Traffic and Transport Assessment
Proposed Residential Development
An Triantán, Station Road, Kildare Town

Client: Kildare County Council

TRAFFIC AND TRANSPORT ASSESSMENT

- 1.1 Roadplan Consulting has been commissioned by CS Consulting to carry out a Stage 1 Quality Audit of a proposed residential development at Station Road, Kildare Town, Co. Kildare.
- 1.2 The proposed development comprises the construction of 30 no. apartment and duplex units, arranged around a central courtyard.
- 1.3 The development is situated at the northwestern side of Kildare Village, on the Station Road. The site has a single access point from the Station Road.
- 1.4 The Circular Road has a speed limit of 50 km/h in the area of the proposed development.
- 1.5 Figure 1.1 indicates the site location and Figure 1.2 is a layout drawing of the development.

5.1 Issue

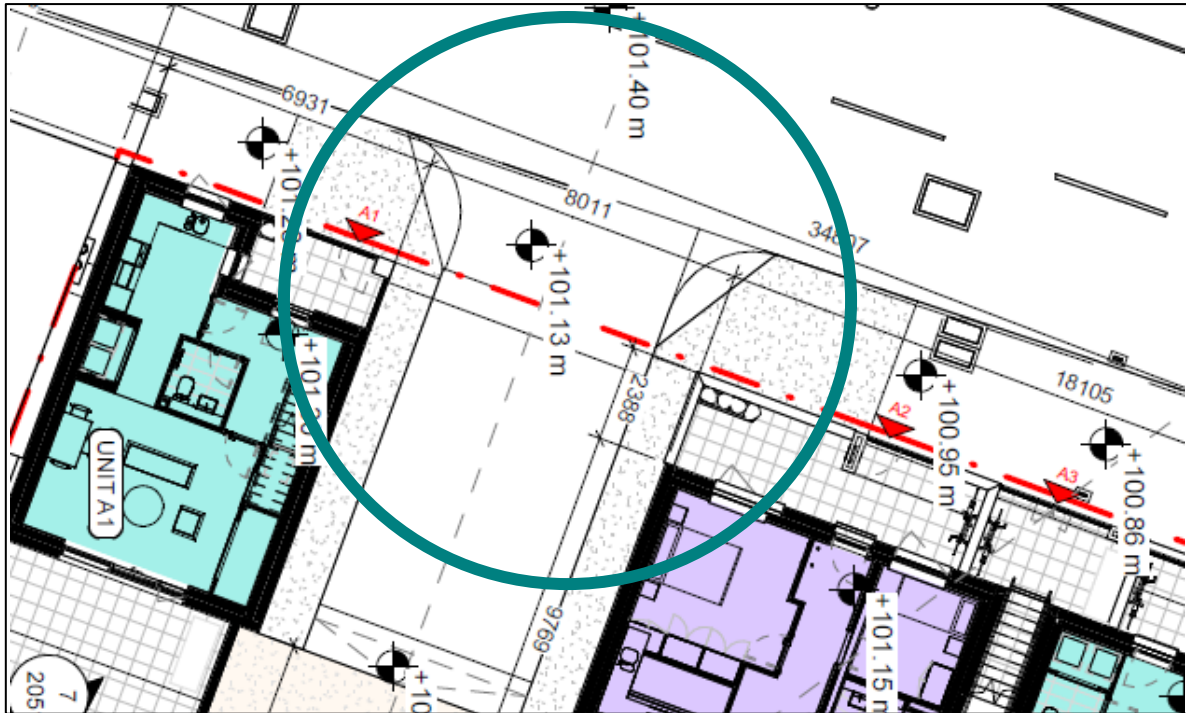
Road markings or traffic signs to indicate junction priority are not shown to be provided at the proposed internal junctions within the development. This may lead to turning collisions if priority at the junctions is unclear to drivers.

Provide adequate junction control (STOP road markings or similar) to clearly define vehicular priority at all junctions.

As shown on drawing **K114-CSC-ZZ-XX-DR-C-0003**, STOP road markings (RRM 017, RRM 001, and M 114) are now provided to regulate priority at the development's access junction.

6.1 **Issue**

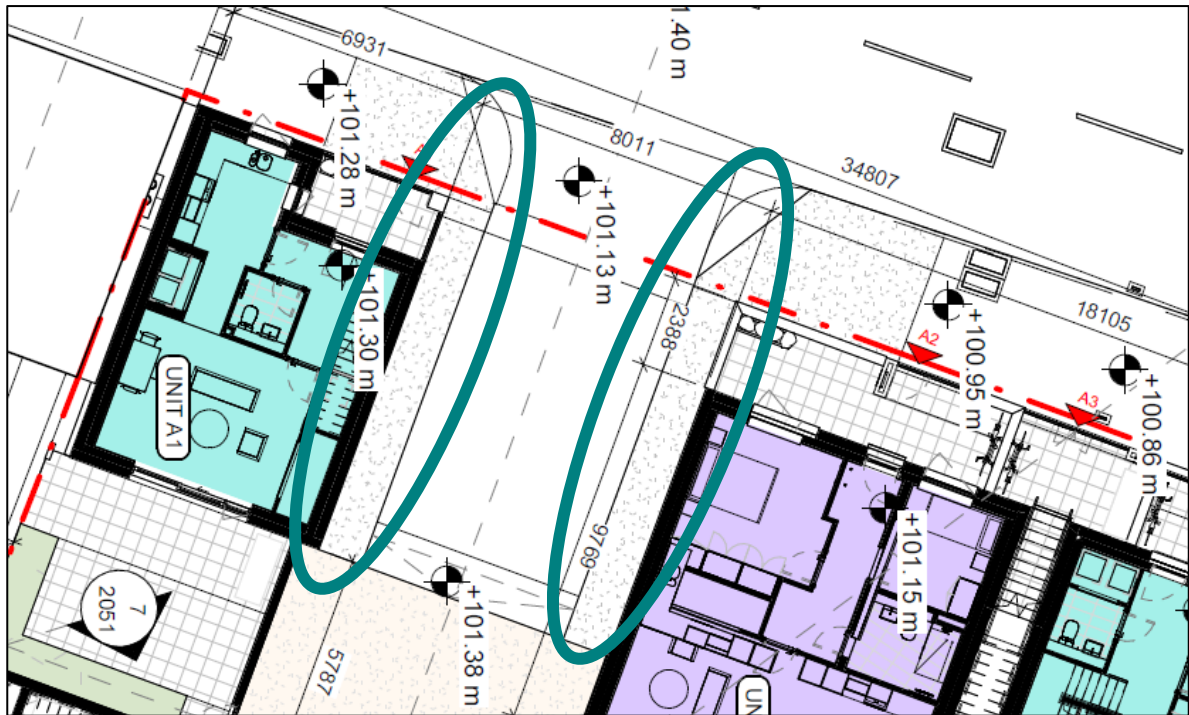
It is unclear if appropriate footpaths widths will be provided for mobility impaired pedestrians resulting in pedestrians walking on carriageways where they would be at an increased risk of being struck by a passing vehicle.

Ensure adequate footpath widths are provide throughout the development.

The audited site layout design included a raised footpath to either side of the development's access off Station Road, each 1.2m in width. The access design has been revised to instead provide a single 1.8m-wide raised footpath along the southern side of the development access.

6.2 **Issue**

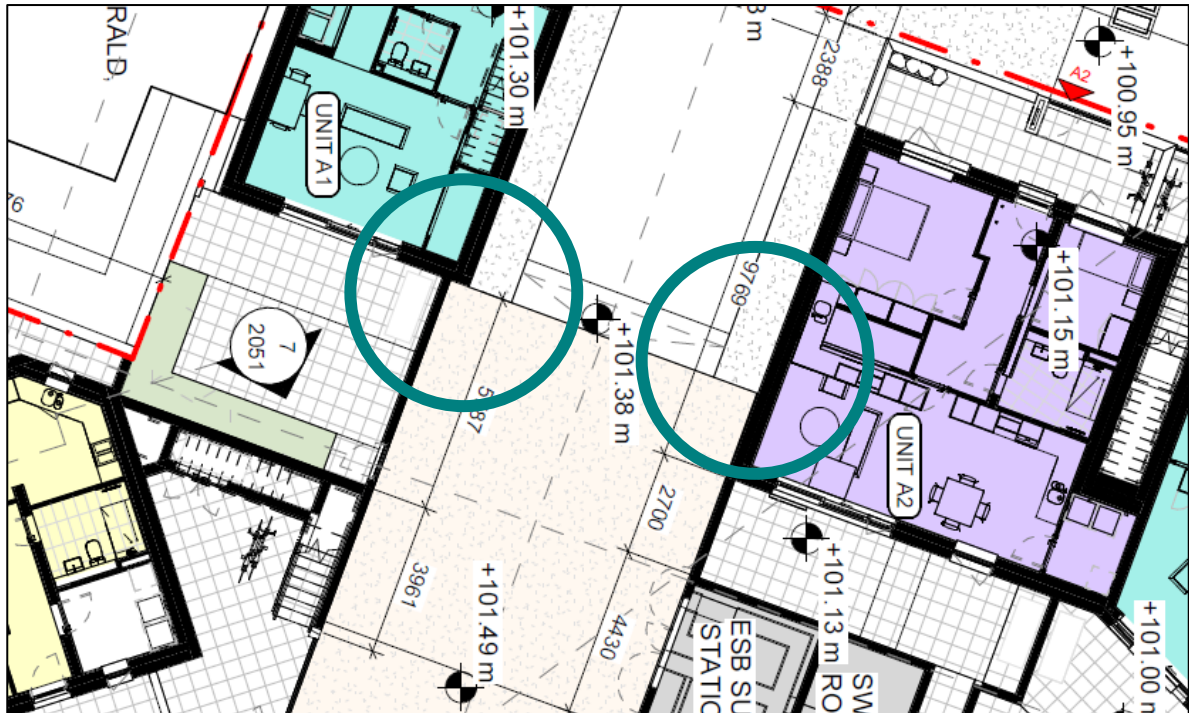
Visually impaired pedestrian may not realise that they are entering into a shared space at the ends of the proposed footpaths. This may contribute to pedestrian collisions within the shared space.

Ensure appropriate corduroy paving is provided at these locations to warn visually impaired pedestrians that they are entering a shared space.

6.3 Issue

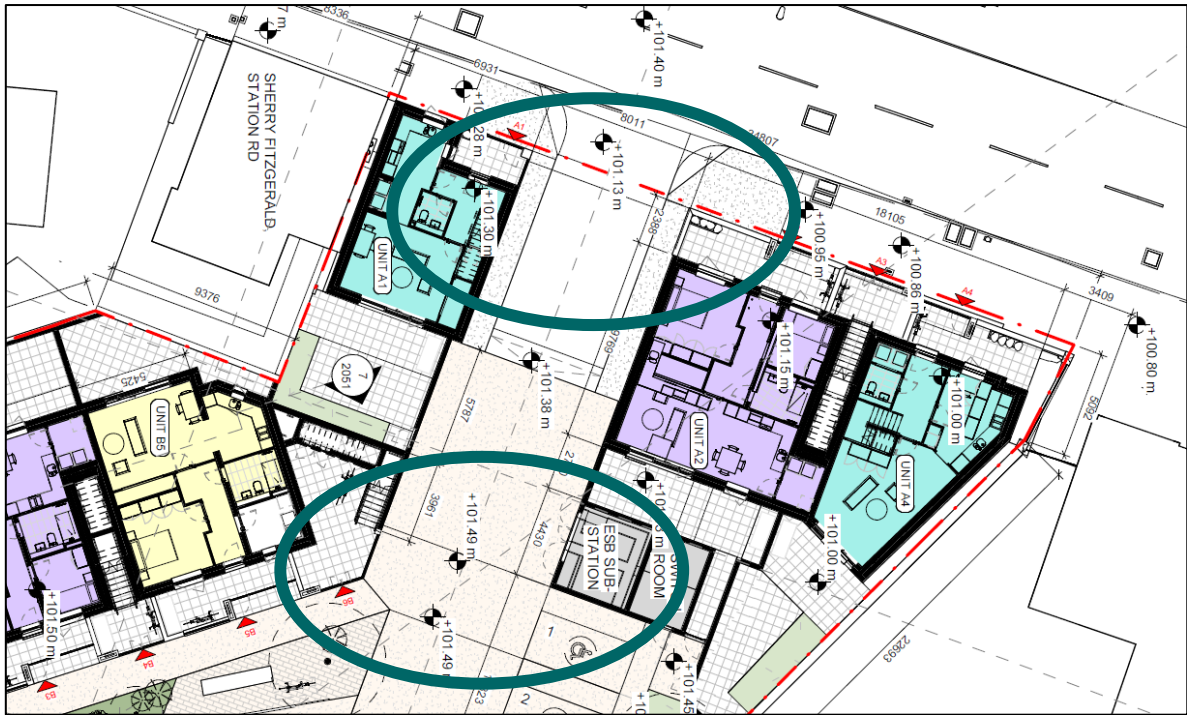
A shared space is proposed through the majority of the proposed development. However, where adequate guidance features are not provided, visually impaired pedestrians may become disoriented in the shared space and may stray onto the central access road, increasing the risk of collisions.

Ensure that measures are provided to provide guidance to visually impaired pedestrians within the shared space.

The internal shared surface paving design has been revised to include contrasting surface finish colours and textured delineation strips, to aid orientation and guidance for visually impaired pedestrians.

6.4 Issue

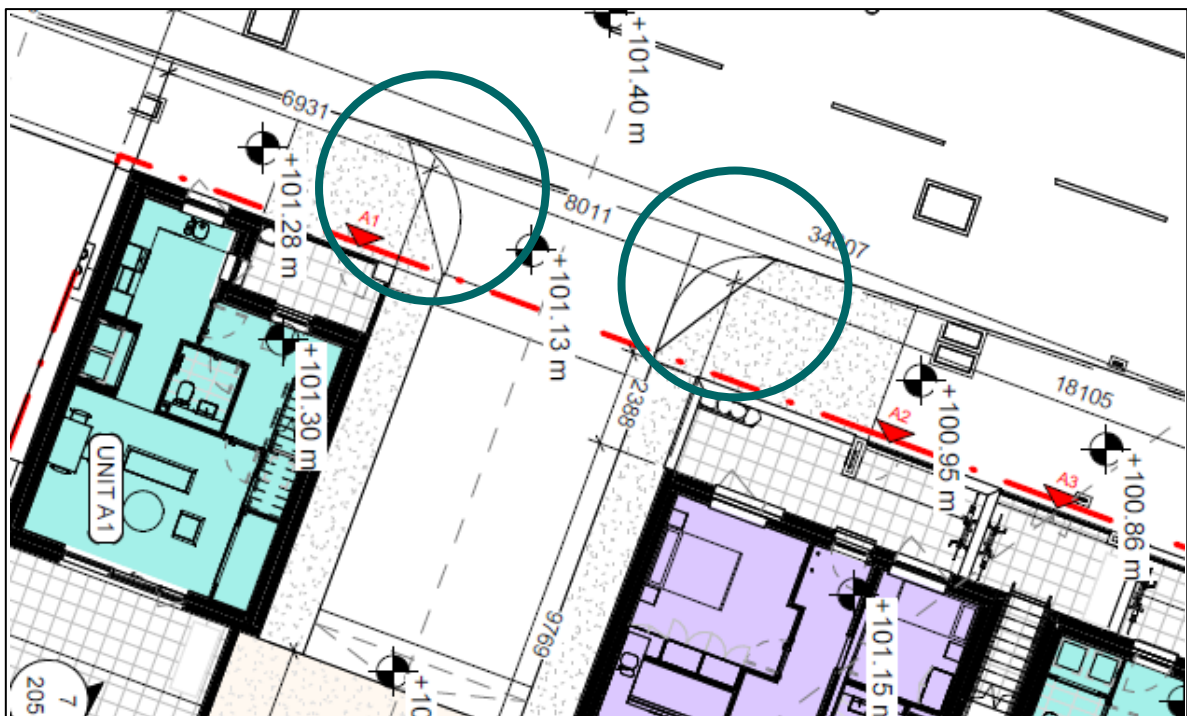
Facilities such as dropped kerbs and tactile paving are not shown to be provided for pedestrians crossing the at the proposed development access. This may cause difficulty or delay for crossing movements by pedestrians and increase the risk of their being struck by passing motor traffic.

Provide facilities such as dropped kerbs and tactile paving for pedestrians crossing the proposed development access.
